Field Safety Notice

Urgent Medical Device Correction - ISIFA2017-02-C

Proper use of da Vinci® Xi EndoWrist Stapler Release Kit

Figure 3: If necessary, press emergency stop button

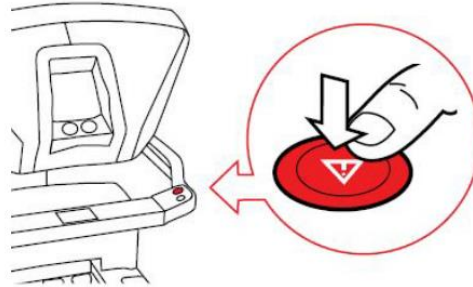
2. If the system is not faulted, press the Emergency Stop button on the Surgeon Console. Do not recover the fault.
